TECHNICAL MEMORANDUM

TO: Mr. Robert Miller, Wallace Group DATE: May 3, 2010
FROM: Peter M. Pyle, P.G., CHG. JOB NO: 2323
RE: Peer Review of the Los Osos Groundwater Model

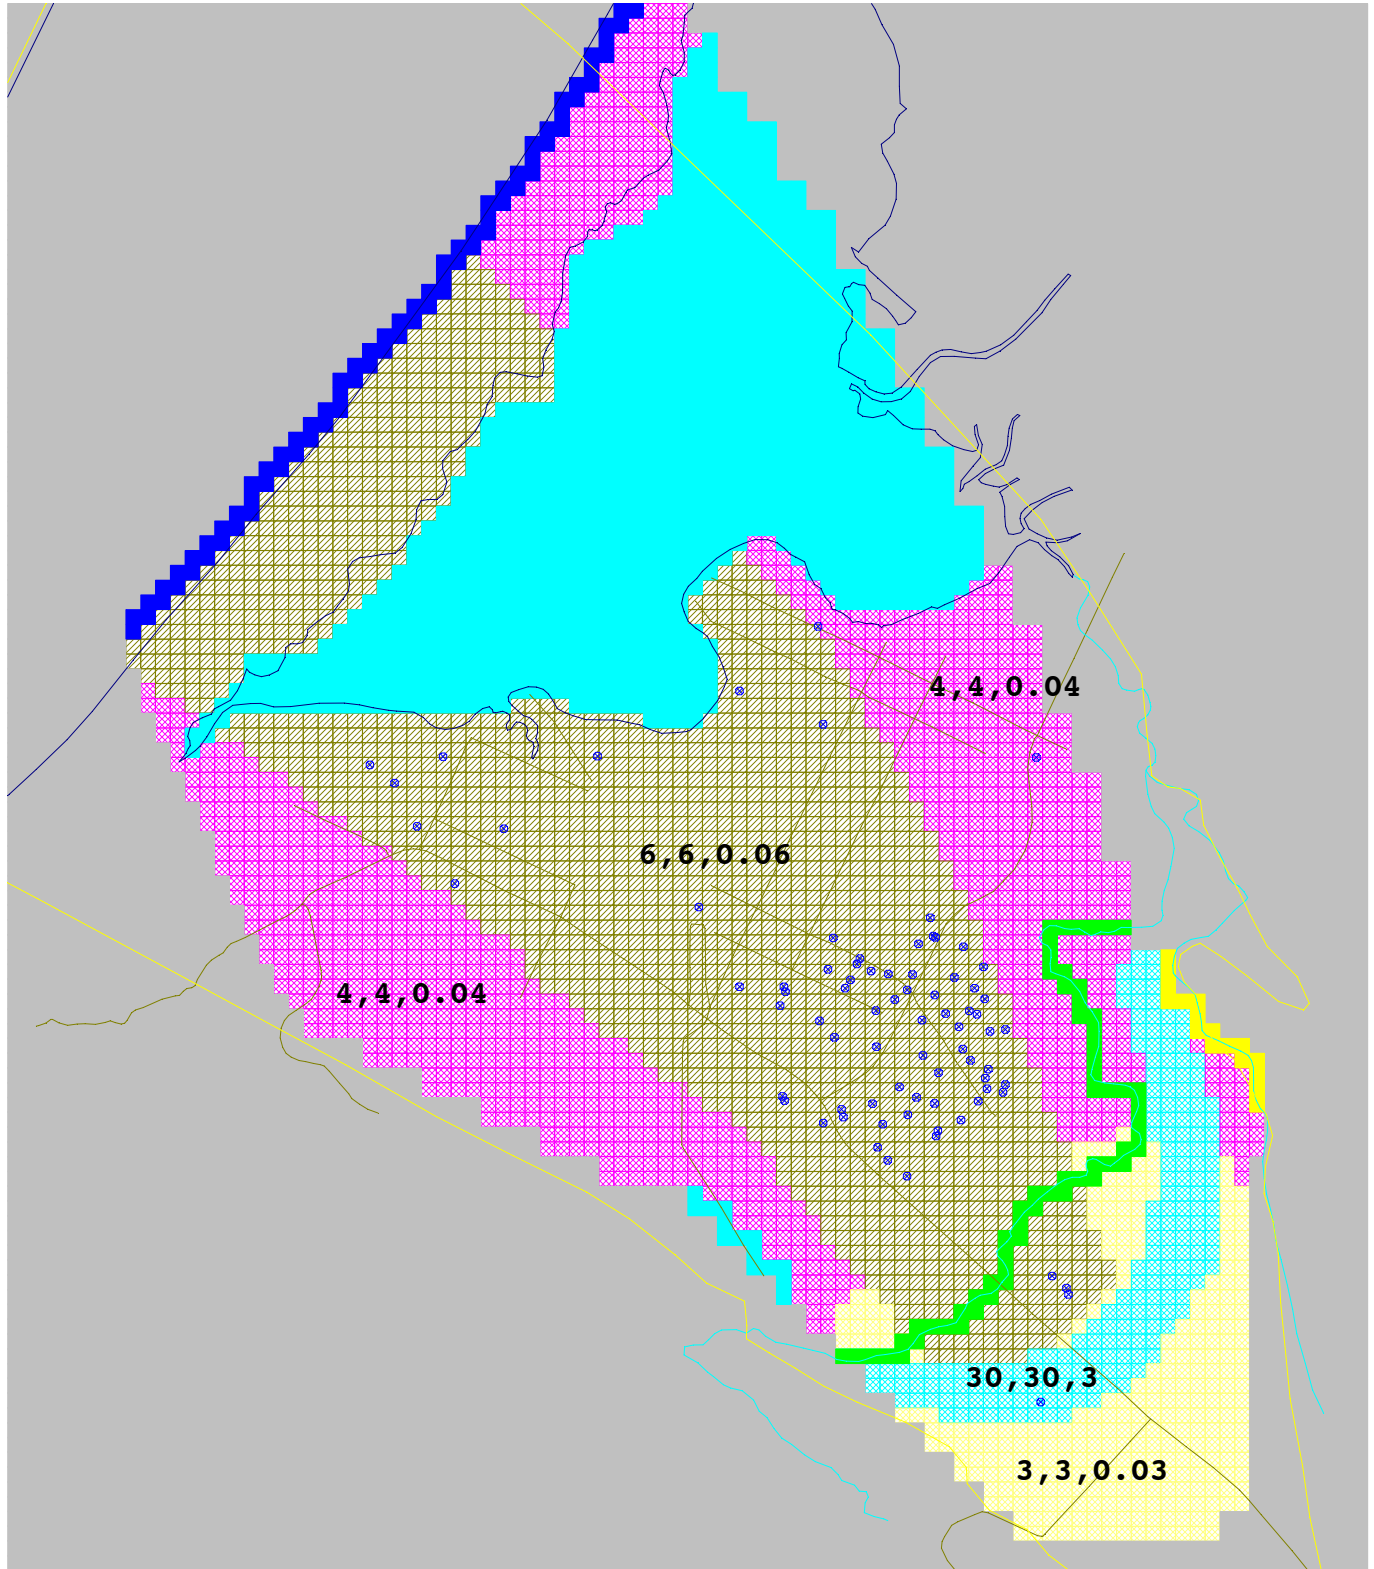
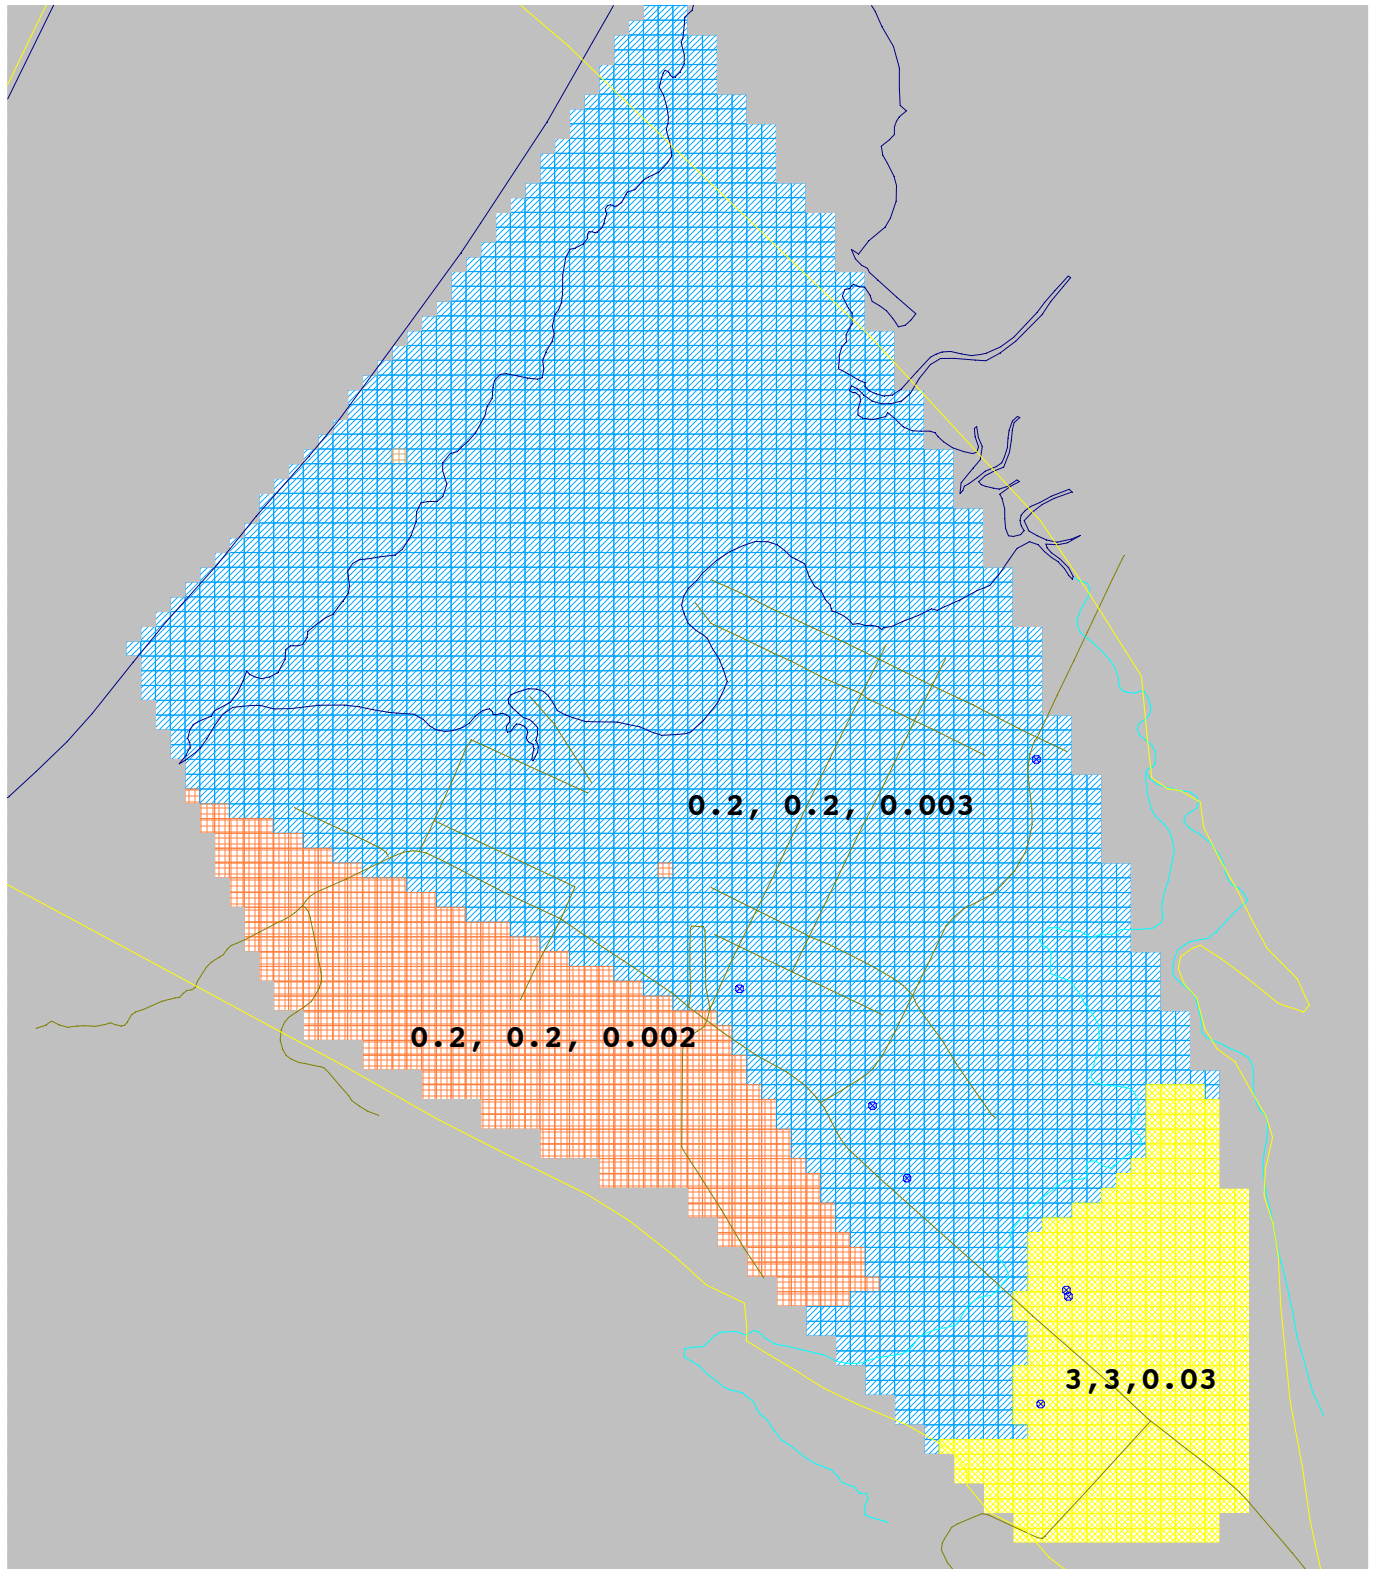
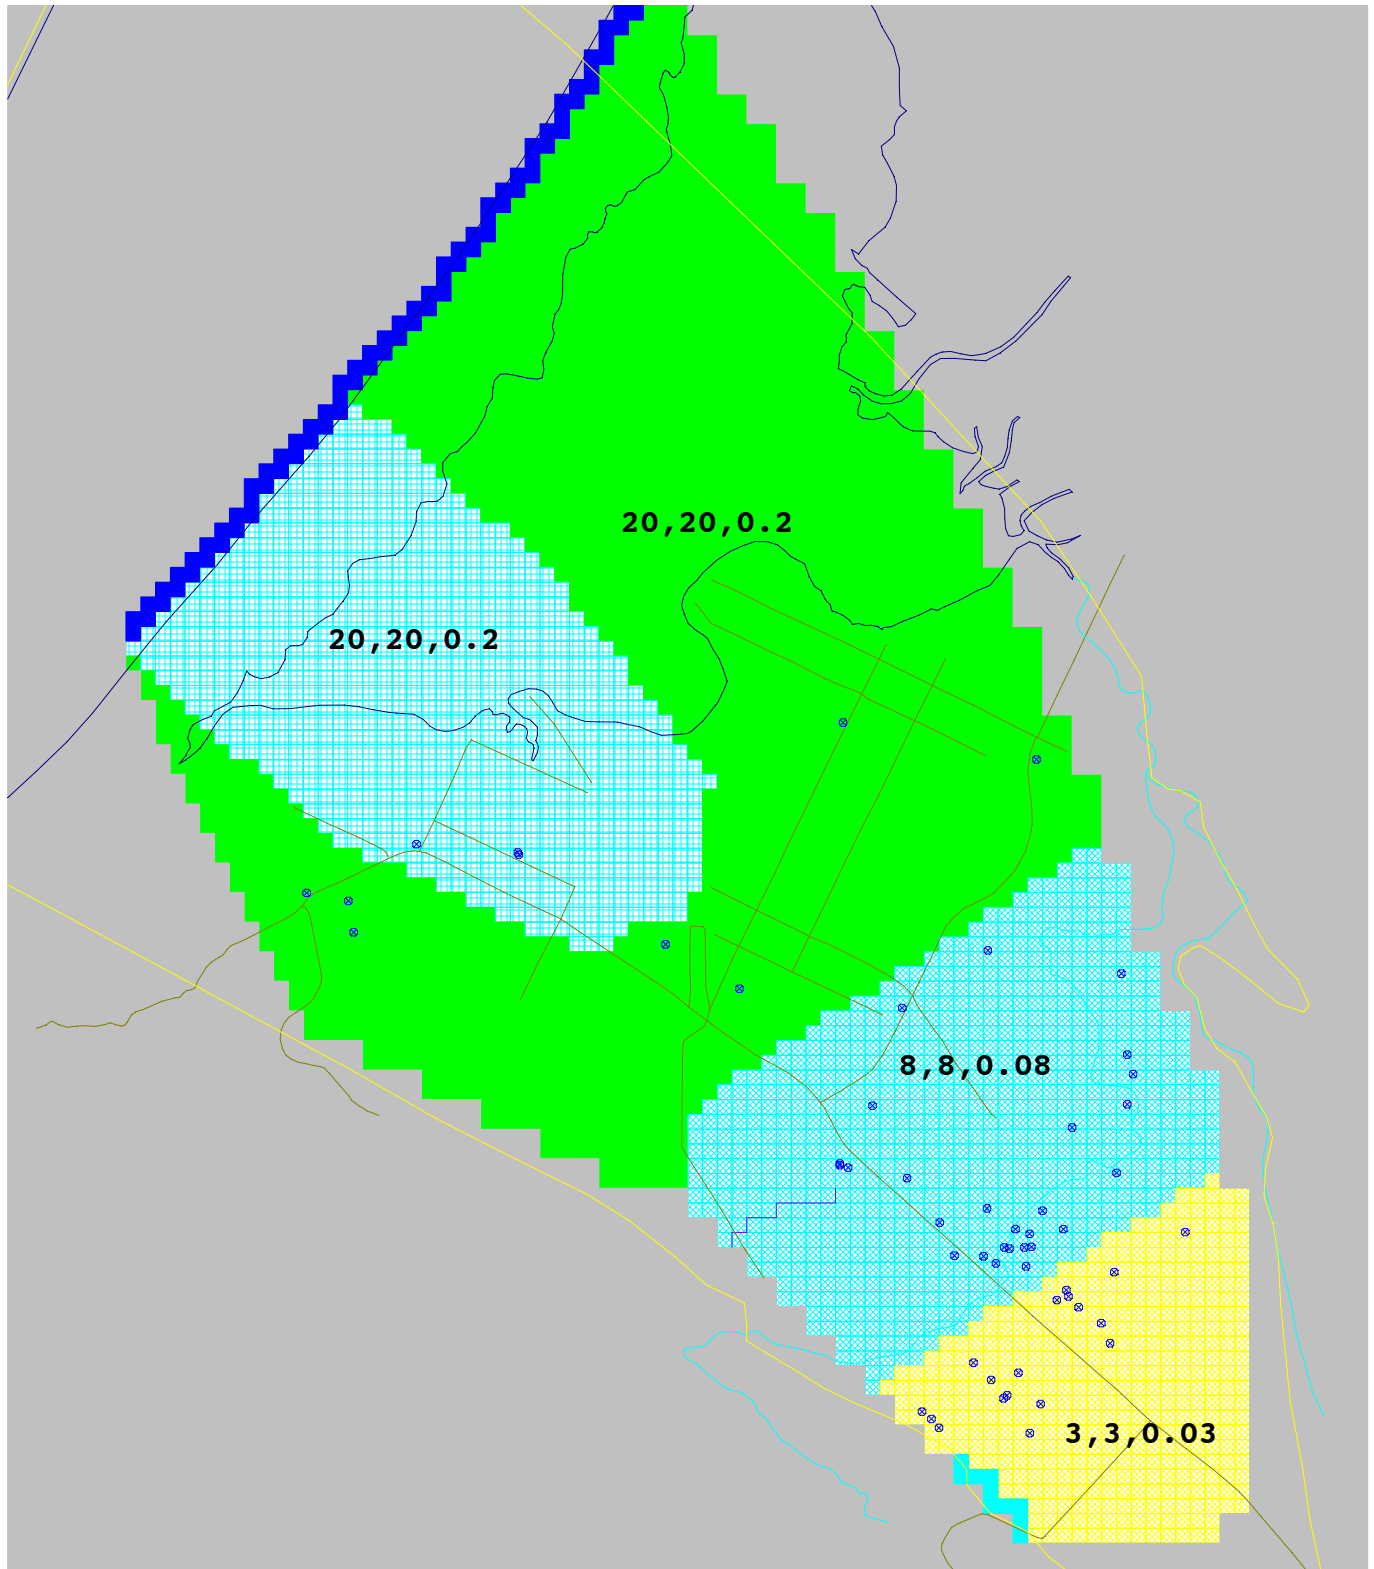
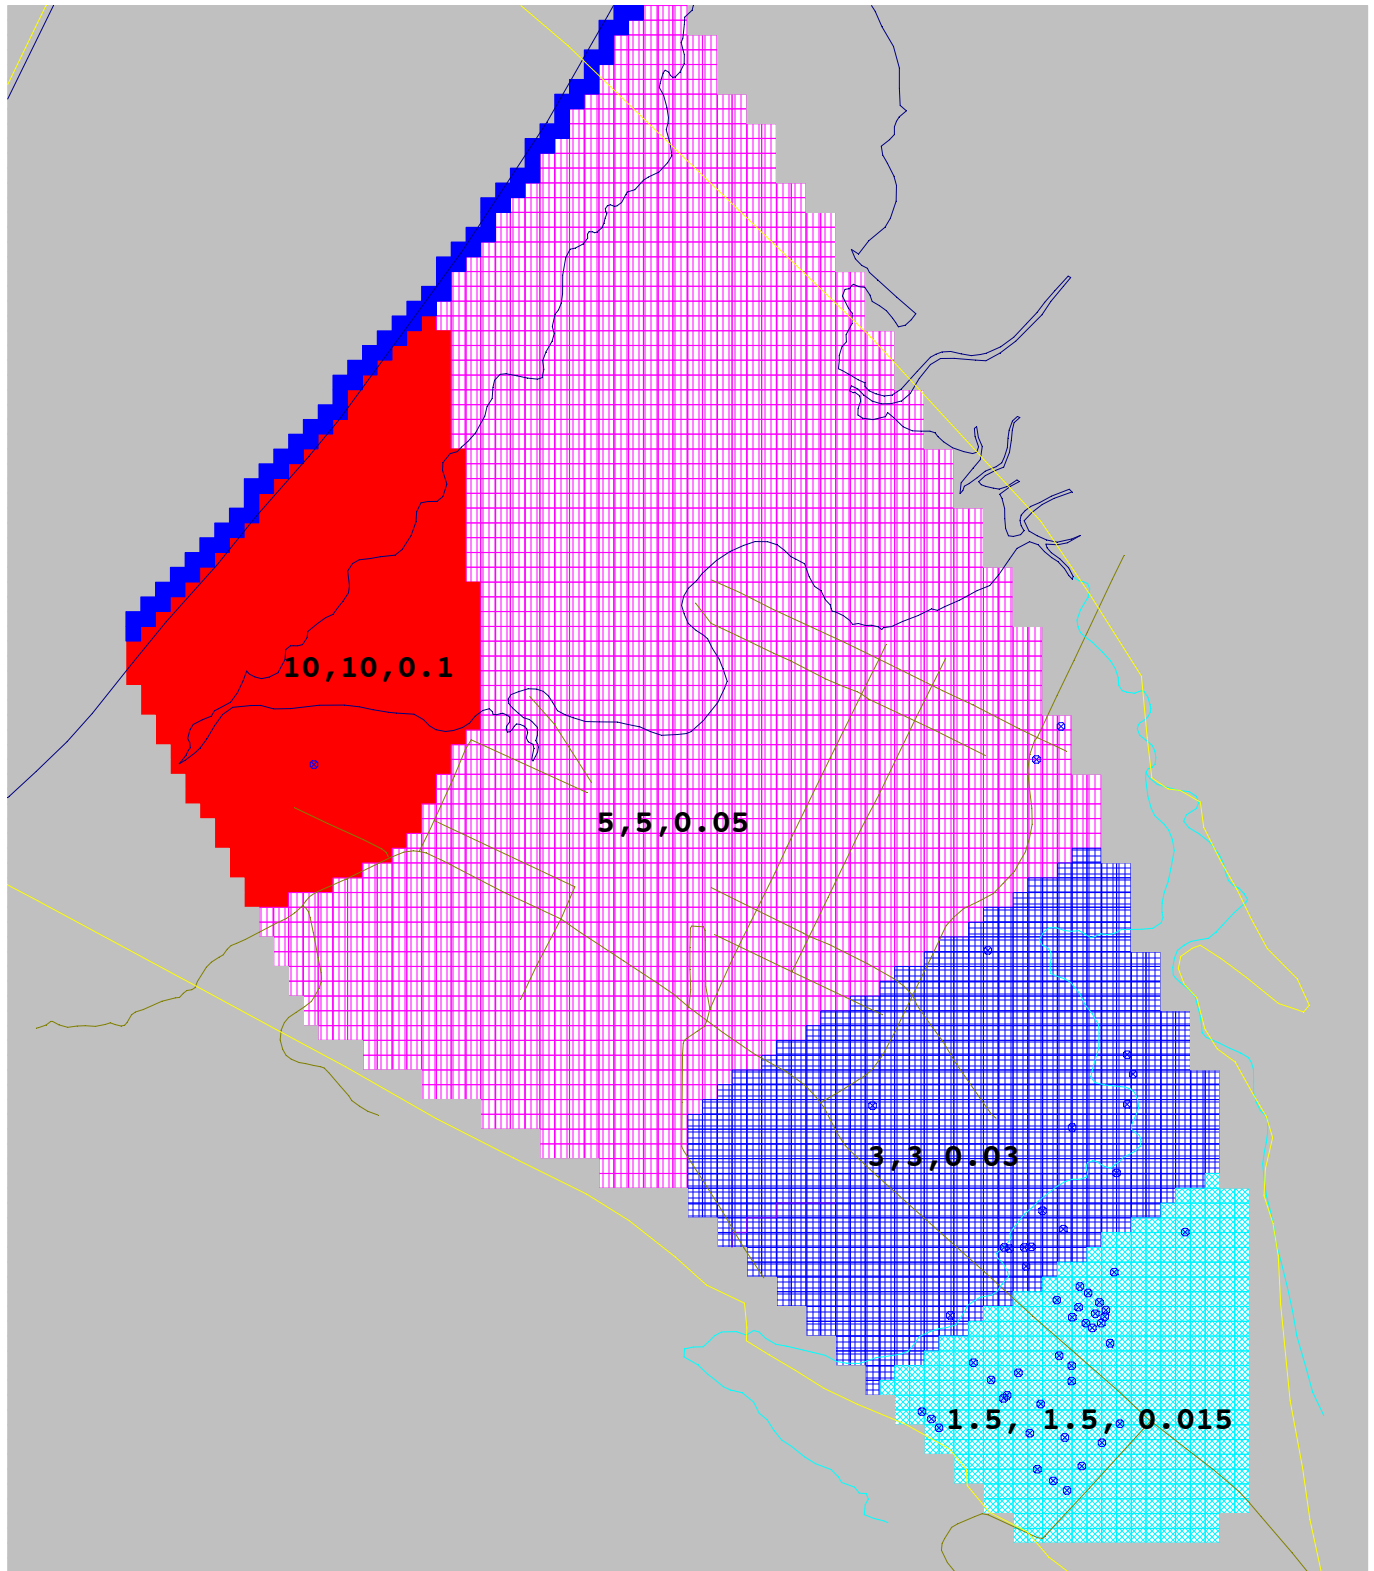
A key hydraulic parameter that controls groundwater and seawater flow in the model is horizontal hydraulic conductivity (Kh). Its distribution by layer were requested from CHG and reviewed. The distribution is shown for each model layer in the attached Figures 1 through 4. This distribution was discussed with Mr. Harris and compared to that of pumping test results presented in Cleath and Associates (2005), and supplemental data provided by Mr. Harris.

The K distribution by layer seems appropriate and honors the field test data, which need not be precisely replicated in the model due to field data limitations and scale. I had questions regarding the K distribution representing the Los Osos Creek alluvium which appeared different from that of typical stream alluvium. However, discussions with Mr. Harris confirmed that the K values used in that area honor the unique geology of this region.

This type of information (maps and discussion of aquifer hydraulic properties) should be included in a future report on the SEAWAT model used in the CHG (2009a,b) studies.

Figure 5. Annual Los Osos Creek Flow (1978-2002)

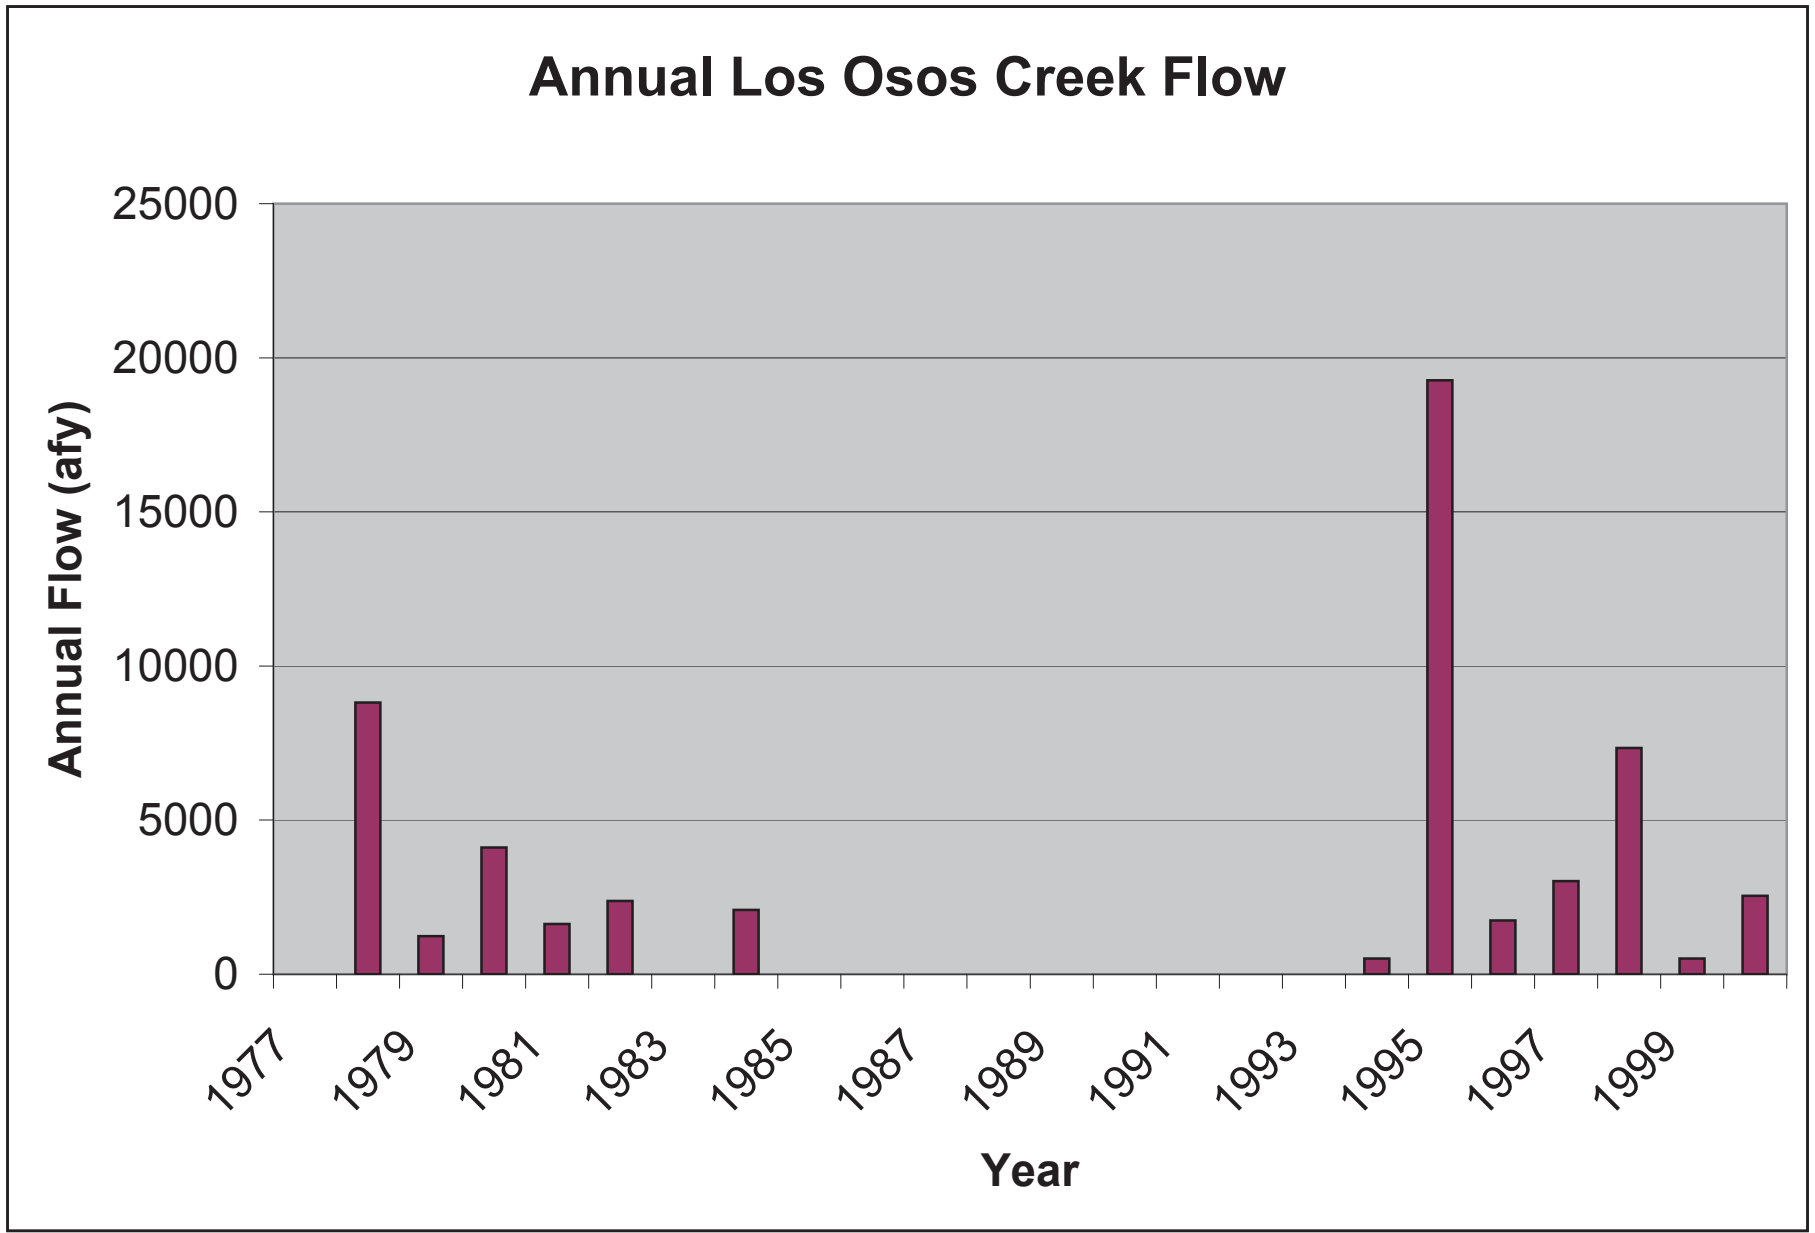
In order to evaluate whether the RIV module was properly used to represent Los Osos Creek seepage, two analyses were performed. For the first, Creek flow data and a precipitation graph with a cumulative departure curve was requested from CHG. The Creek flow data is shown in Figure 5. It shows that data is missing for 1983, a wet year, and 1985-93 most of which were dry years. The wet or dry year condition was determined using long term precipitation data with a cumulative departure curve requested from CHG (Figure 6). A comparison of Figures 5 and 6 indicate the creek flow data is skewed to wet years.

The average creek flow for all of the years shown is 3,940 afy with a median of 2,230 afy. If a balance period is selected (Figure 6) which is limited to 1979-81 creek flow data (Figure 5), the average is 2,326 afy with a median of 1,630 afy. This suggests that no more than about 1,600 afy should be allowed by the model to seep from the stream to the underlying aquifer. The results of the increased pumping in the Los Osos creek subarea by CHG (2009b) is well within this limit at 1,013 afy. In addition, the gage from which the flow data in Figure 5 was obtained is located somewhat downstream from the basin and model boundary such that some seepage to the aquifer can occur in the groundwater basin upstream of the gage. The STR package will allow more accurate representation of stream leakage in future revisions of the model.
